BGA TECHNICAL COMMITTEE

TECHNICAL NEWSHEET 9/10/98

PART 1 Airworthiness "AGGRO"

FIGURE 1

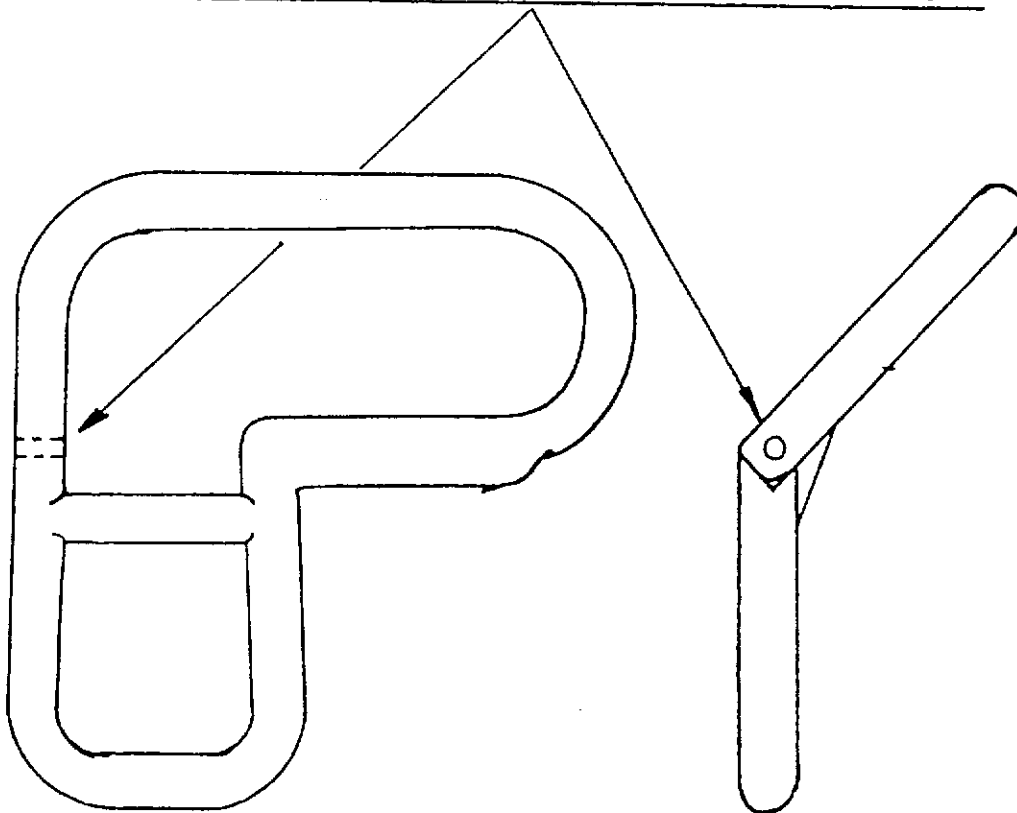
=====
80-13-01 STRONG ENTERPRISES: Amendment 39-3793. Applies to all angled plastic parachute ripcord handles (P/N 1034) to which the ripcord cables are attached through only one leg of the handle and not attached through the drilled reinforcing crossbar in a lengthwise direction (see Figure 1). These handles were manufactured by Strong Enterprises in accordance with FAA Technical Standard Order (TSO) C-23b, Parachutes, for use on Strong Enterprises "Pop-Top" Chest-Mounted Reserve Parachutes (P/N 1023), but may be found on parachutes of other makes, models or types.

REPLACE THIS HANDLE IF
RIPCORD CABLE ATTACHES HERE

To prevent the possible nondeployment of a parachute canopy due to separation of the plastic handle from the ripcord cable when subjected to the deployment pull force, accomplish the following: replace the plastic handle shown in Figure 1 with a metal handle (P/N 1025) supplied by Strong Enterprises prior to the parachute being made available for any parachute jump.

OLYMPIA 2B - ELEVATOR

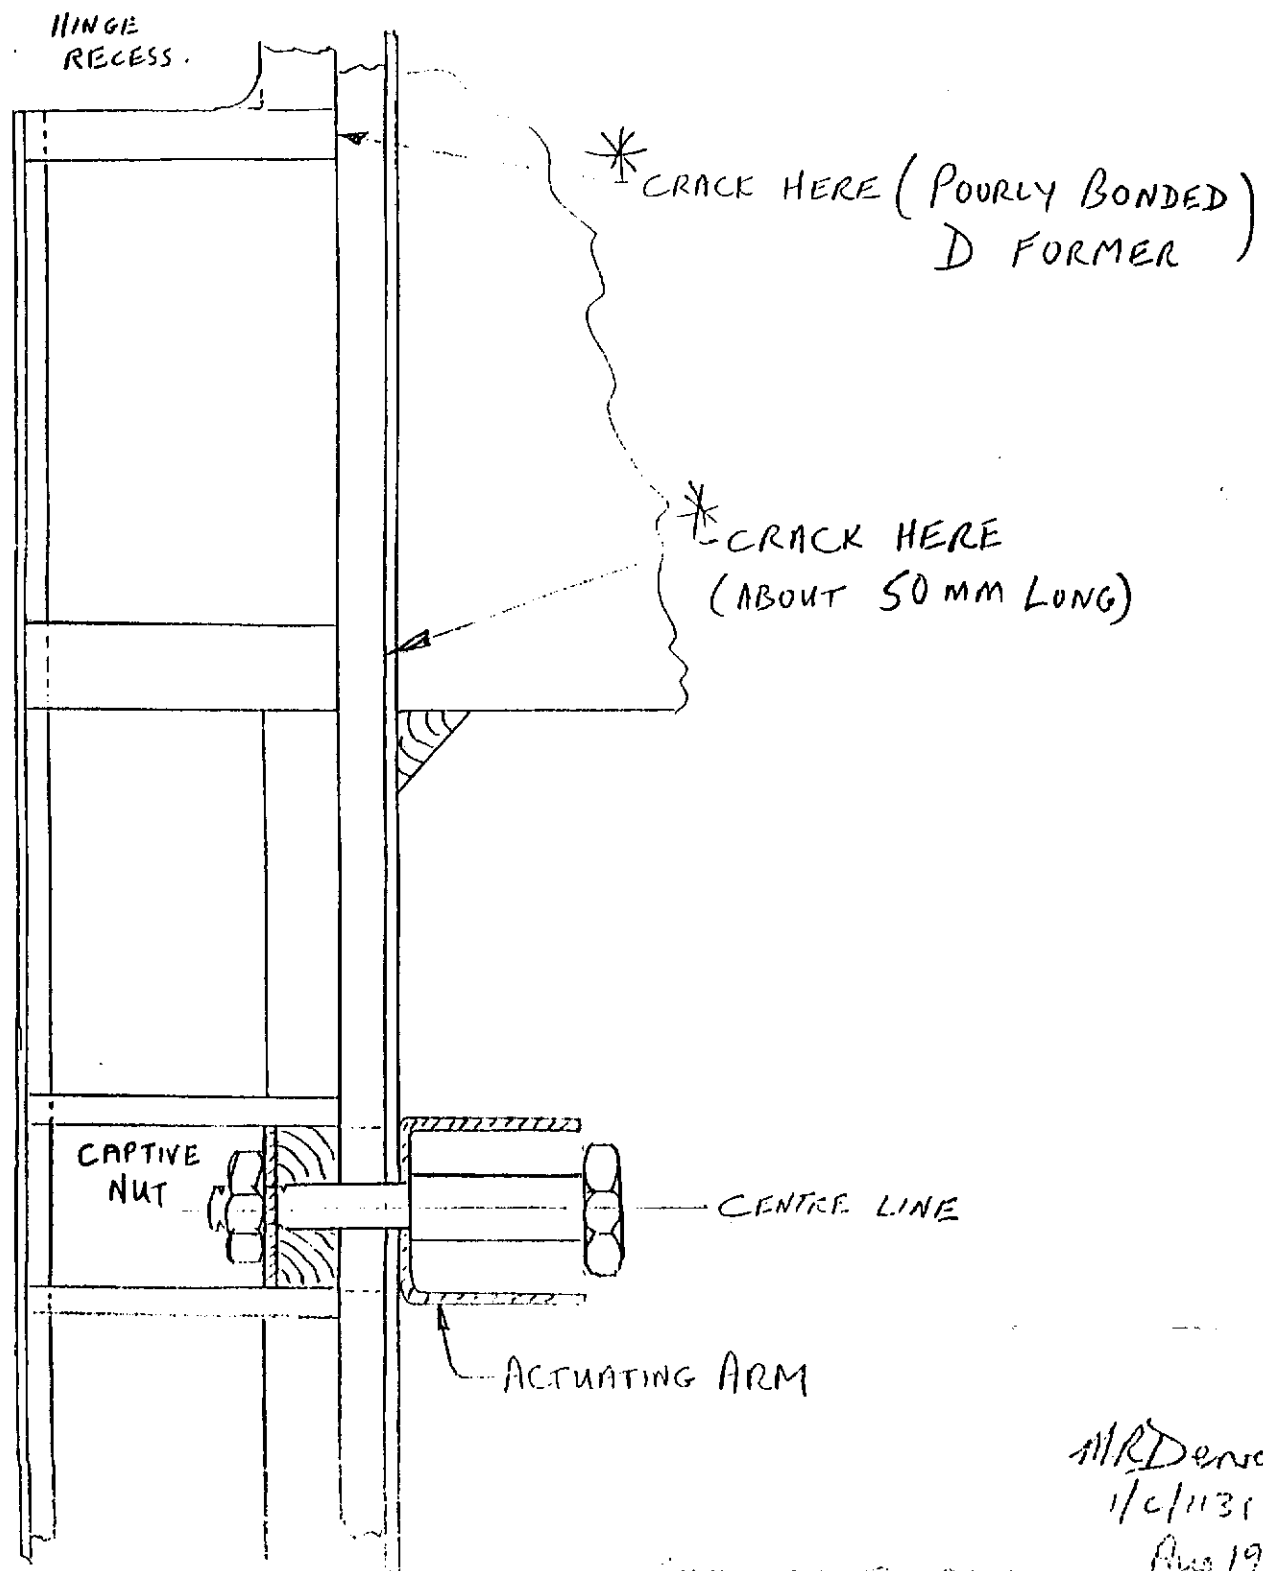
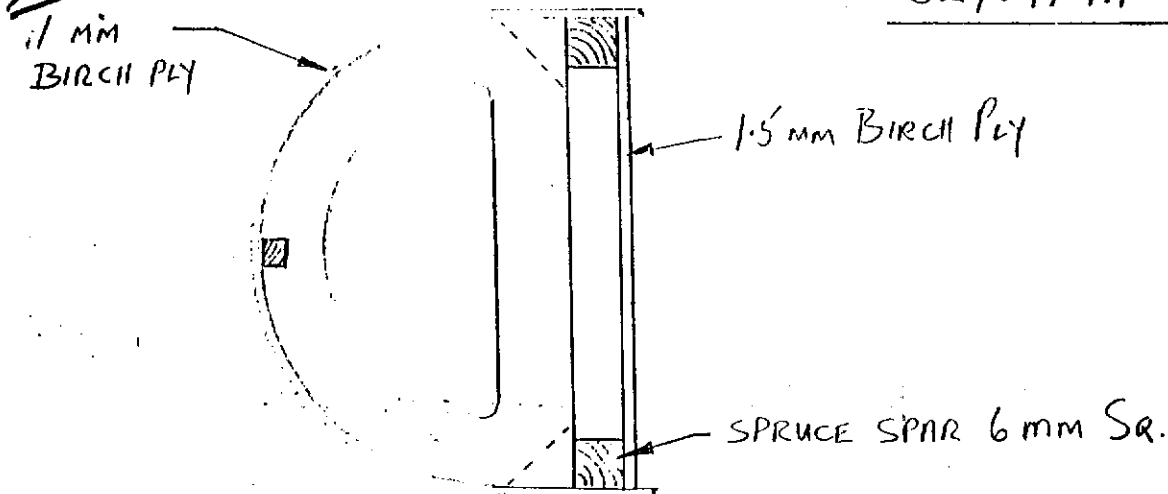
- 1.4. OLYMPIA 2B - Cracks in the Elevator are illustrated in attached sketch from Mr. Derwent.
- 1.5. DART 17R - Elevator Flutter was caused by backlash between the two elevators. (Reported by Enstone Eagles G.C.).

OBJET : MODIFICATION FORME DE LA POIGNEE DE TRAIN.

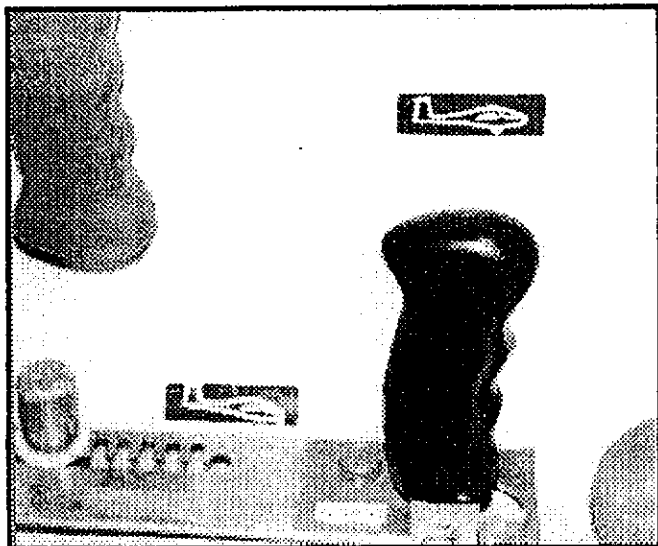
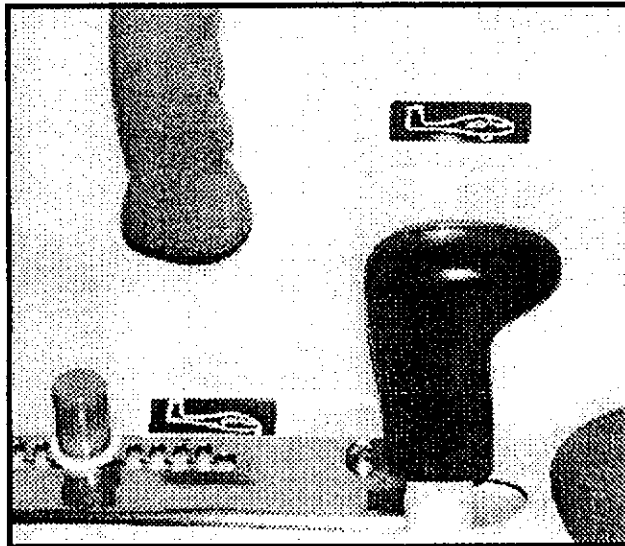
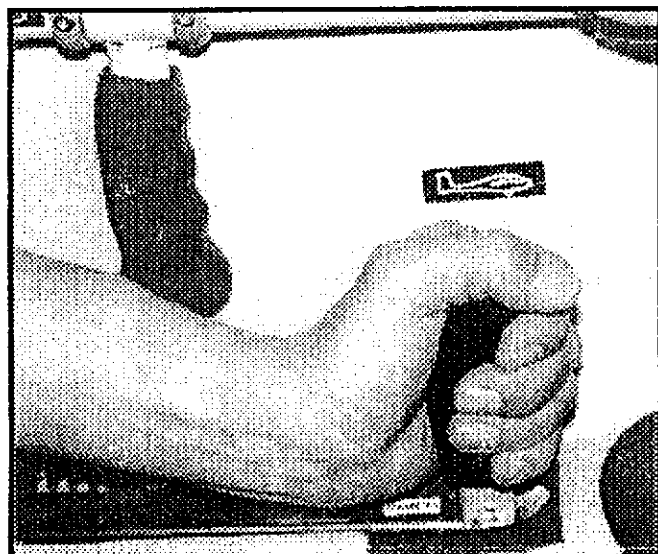
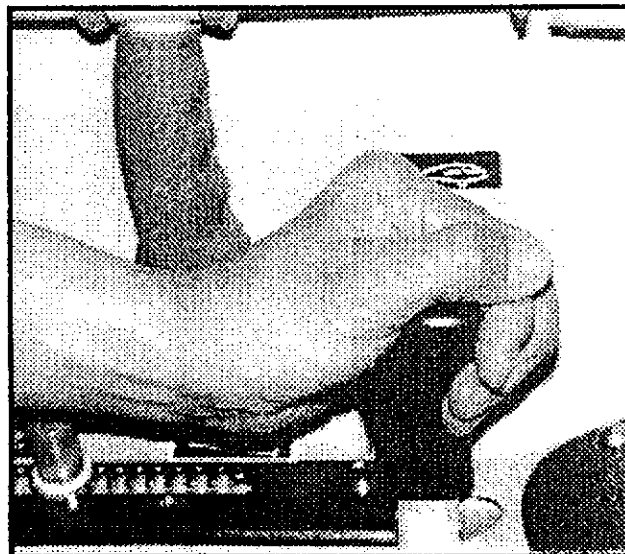
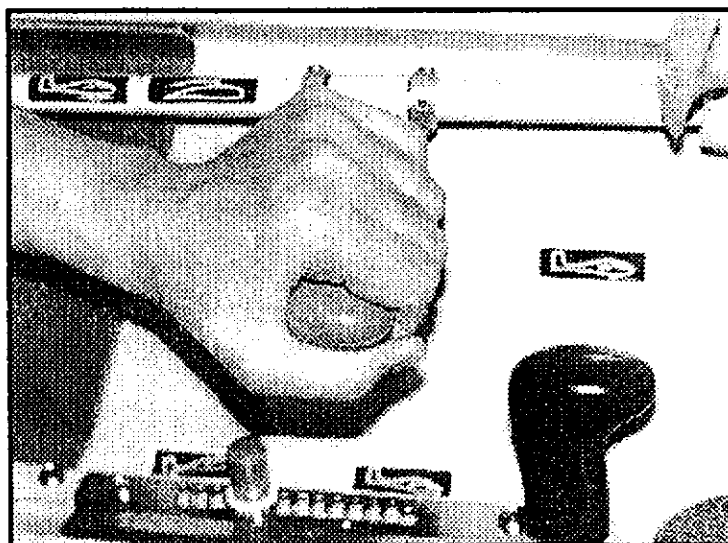
BUT : Limiter le risque de confusion entre
la poignée de commande de train et
la poignée de commande des aérofreins.

Sur les planeurs Pégase, la poignée de commande du train se trouve sur le côté gauche, à proximité de la commande des aérofreins. Malgré la couleur et le mode de déverrouillage qui diffèrent d'une commande à l'autre, un risque de confusion est toujours possible, notamment lorsque le pilote a perdu une grande partie de son attention (fatigue d'un long vol, stress dû à une situation délicate, etc.).

Afin de limiter ce risque de confusion, une nouvelle poignée dont la forme est différente de celle des aérofreins, a été mise en service depuis quelques années (modification mineure 101-10). Les figures de la page suivante montrent les deux types de poignée et leur mode de préhension.

Cette poignée est interchangeable avec l'ancienne et peut donc être installée rapidement sur tous les planeurs Pégase en service.
